Project	IEEE 802.16 Broadband Wireless Access Working Group < http://ieee802.org/16 >	
---------	--	--

Title	Effective utilization for packing and fragmentation subheader	
-------	--	--

Date Submitted	2004-05-10	
----------------	-------------------	--

Abstract	This contribution is to propose the effective packing and fragmentation algorithm.	
----------	--	--

Figure 1 "Packing information within a single MAC PDU"

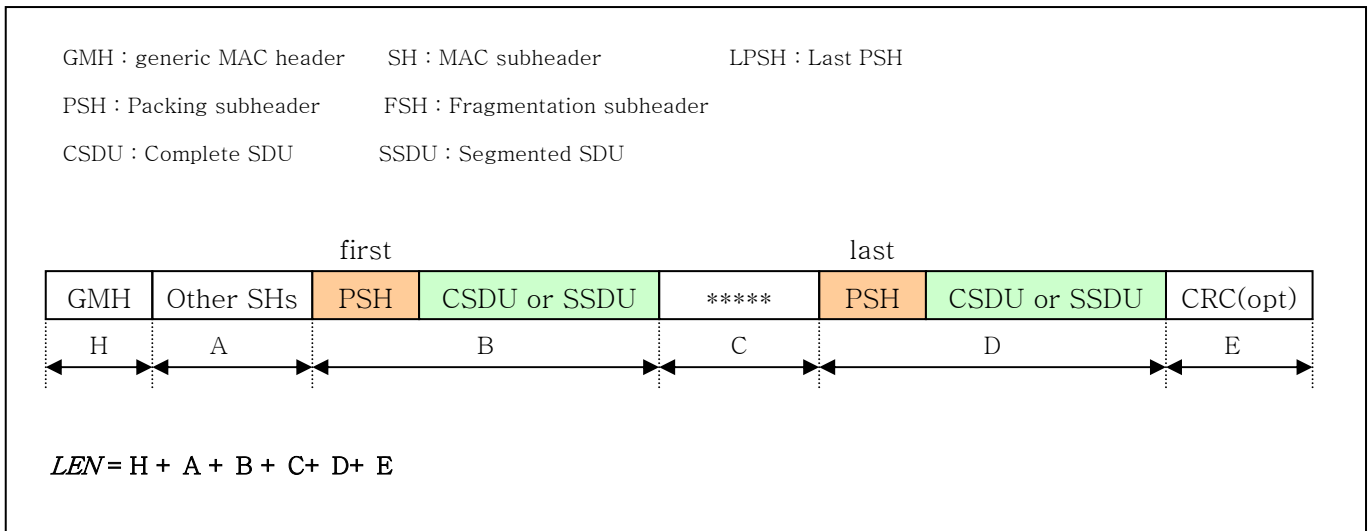
In figure1, all of the PSHs within a single MAC PDU contain 11bits 'length' field. This 'length' field is used for addressing individual beginning of each CSDU/SSDU within the same MAC PDU.

Problem is the 'length' field in the last PSH within a single MAC PDU. Receiver can calculate the size of the last CSDU/SSDU without the corresponding PSH's 'length' field. Therefore, when fragmentation and packing are allowed within the same MAC PDU, the last packing subheader in that MAC PDU can be replaced with an appropriate fragmentation subheader.

Packing and Fragmentation subheaders are allowed to be used in the same MAC PDU. When Fragmentation subheader and Packing subheaders coexist within the same MAC PDU, the last packing subheader in that MAC PDU can be replaced with an appropriate fragmentation subheader. The Packing and Fragmentation subheaders are mutually exclusive and shall not both be present within the same MAC PDU.

When Packing (see 6.3.3.4) is used, the MAC may pack multiple SDUs into a single MAC PDU. When packing variable-length MAC SDUs, the MAC precedes each one with a Packing subheader. .When the Type field indicates that both packing and fragmentation coexist within a MAC PDU (i.e. Type field = "ddd11d") fragmentation subheader is used for the last piece of payload (i.e. MAC SDU or MAC SDU fragment) .
